## **Proposal for further amendments to Regulation No. 10 (Electromagnetic Compatibility)**

The text reproduced below was originally prepared by the expert from Belgium for the proposal for further amendments to Regulation No. 107 to align the additional safety prescriptions for trolleybuses (Annex 12) with the corresponding electrical standards (see ECE/TRANS/WP.29/GRSG/2013/16). During discussion in the October 2013 session of GRSG it appeared that some Contracting Parties are of the opinion that the prescriptions for electromagnetic compatibility of trolleybuses belong in Regulation No. 10. So these prescriptions are taken out of the amended proposal (ECE/TRANS/WP.29/GRSG/2014/19) and are proposed here for consideration by GRE for further actions.

**(a) Vehicle broadband reference limits**  
**Antenna vehicle - overhead contact line separation 10 m**

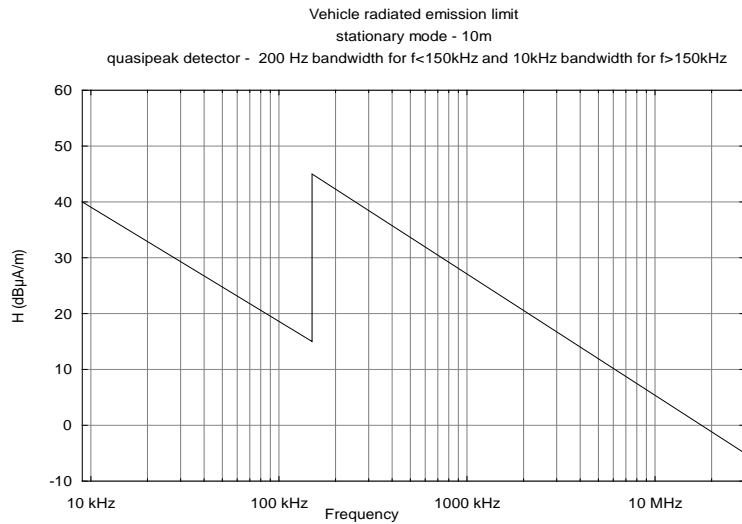
- 1.3. Reference limits for emission of the vehicle for type approval are as specified in the following diagrams:**

**Limit H (dBμA/m) at frequency F (MHz):**

**0.009 – 0.150 MHz**

**0.150 – 30 MHz**

$$H = 40 - 20.46 \cdot \log ( F / 0.009 )$$

$$H = 45 - 21.73 \cdot \log ( F / 0.15 )$$

**(b) Vehicle broadband reference limits**  
**Antenna vehicle - overhead contact line separation 10 m**

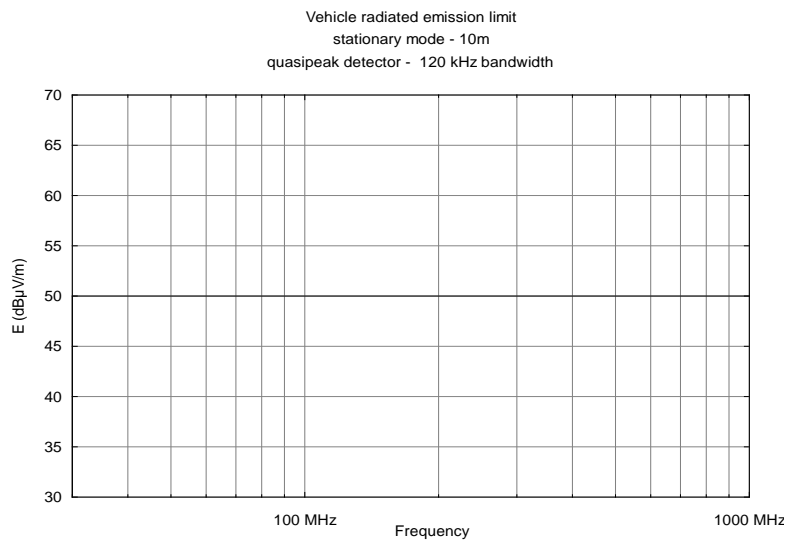
**Limit E (dBμV/m) at frequency F (MHz):**

**30 – 1000 MHz**

$$E = 50$$

**(c) Vehicle broadband reference limits**  
**Antenna vehicle - overhead contact line separation 10 m**

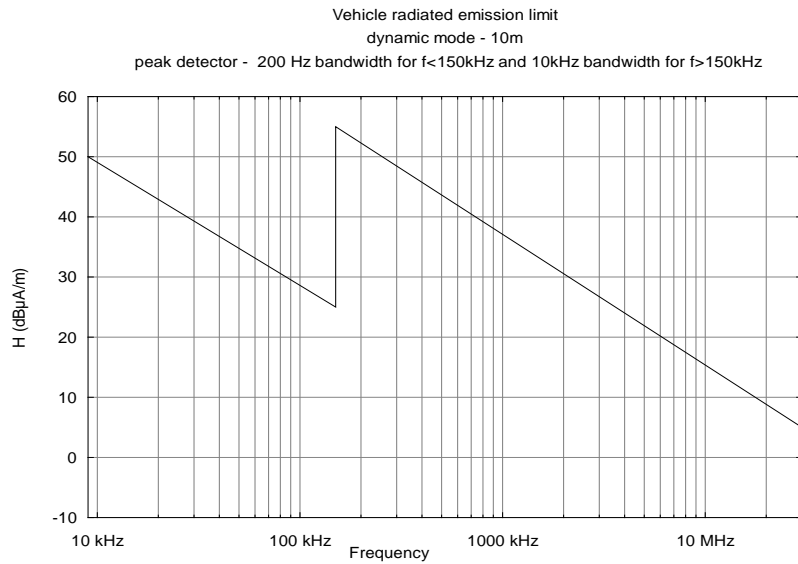
**Limit H (dBμA/m) at frequency F (MHz):**

**0.009 – 0.150 MHz**

**0.150 – 30 MHz**

$$H = 50 - 20.46 \cdot \log ( F / 0.009 )$$

$$H = 55 - 21.73 \cdot \log ( F / 0.15 )$$

**(d) Vehicle broadband reference limits**  
**Antenna vehicle - overhead contact line separation 10 m**

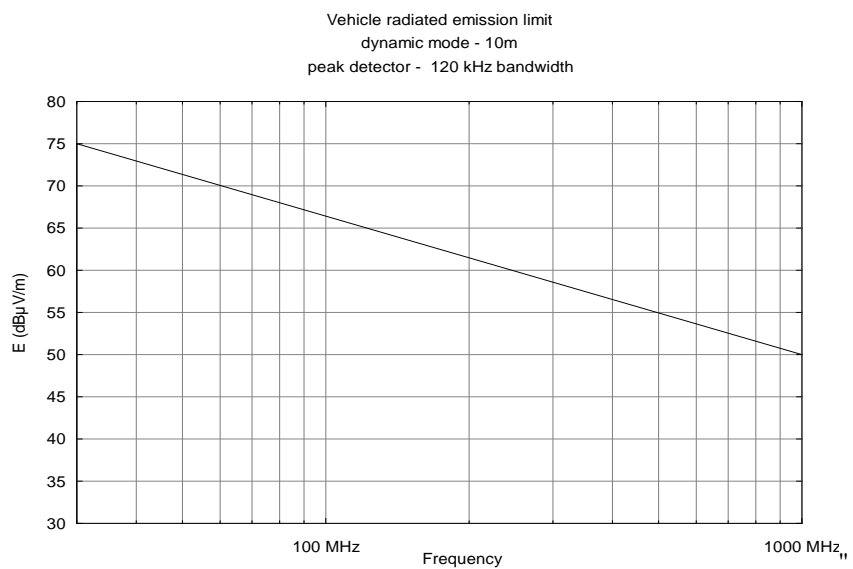
**Limit E (dBμV/m) at frequency F (MHz)**

**30 – 1000 MHz**

$$E = 75 - 16.42 \cdot \log ( F / 30 )$$
